# Access Compliance Report

## Public Rights-of-Way

Intersection ID: 27384	Main Street: DOVEHUNT_PL	Cross Street: VALLEY_SPRING_DR	Location: W
ADA ID: FECC5B94990E	Ramp Type: PerpDiag	Initial Pass/Fail: Fail	Overall Compliance: No
Severity Score: 25			
Codes/Mitigation Info/Possible Solution		Field Measurements/Component Compliance

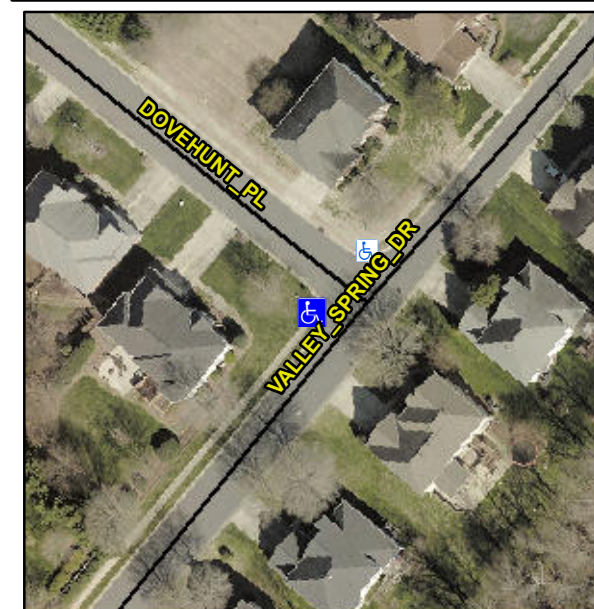
**Not Found, R304.2.2, R304.5.3**

Compliance	Description	Data	Compliance	Description	Data
N/A	Ramp Length (in)	47.0	No	Ramp Slope (%)	9.1
Yes	Ramp Width (in)	48.0	No	Ramp XSlope (%)	5.5
N/A	Flare Type LT	N/A	N/A	Flare Type RT	N/A
N/A	Flare Slope LT (%)	N/A	N/A	Flare Slope RT (%)	N/A
N/A	Flare Traversable LT?	N/A	N/A	Flare Traversable RT?	N/A
N/A	Landing Length (in)	N/A	N/A	DWS Provided?	N/A
N/A	Landing Width (in)	N/A	N/A	DWS Contrast?	N/A
N/A	Landing Slope (%)	N/A	N/A	DWS Length (in)	N/A
N/A	Landing X Slope (%)	N/A	N/A	DWS Full Width?	N/A
N/A	Landing Curb? (Y/N)	N/A	N/A	DWS Offset (in)	N/A
N/A	Shared Landing?	N/A			
N/A	Gutter Ponding?	N/A	N/A	Gutter Slope (%)	N/A
N/A	Gutter Lip Ht (in)	N/A	N/A	Gutter X Slope (%)	N/A
N/A	Painted X Walk1?	No	N/A	Painted X Walk2?	No
	X Walk 1 Direction	To SE		X Walk 2 Direction	To NE
N/A	X Walk 1 Width (in)	N/A	N/A	X Walk 2 Width (in)	N/A
	X Walk 1 Slope (%)	0.6		X Walk 2 Slope (%)	7.2
	X Walk 1 X Slope (%)	8.1		X Walk 2 X Slope (%)	0.4

N/A	Ramp inside XWalk1?	N/A	N/A	Ramp inside XWalk2?	N/A
	Road Slope (%)	4.2	N/A	Clear Space?	N/A
	Road X Slope (%)	6.1	N/A	Clear Space to XWalk (in)	N/A
N/A	Any Obstructions?	N/A	N/A	Storm Grate/Utility Hazard?	N/A
	Obstruction Type			Storm Grate/Utility Type	
		N/A			N/A
			Yes	Surface Condition? (G/P)	Good

**Remove & Replace Curb Ramp With Two New Directional Ramps or Equivalent.**
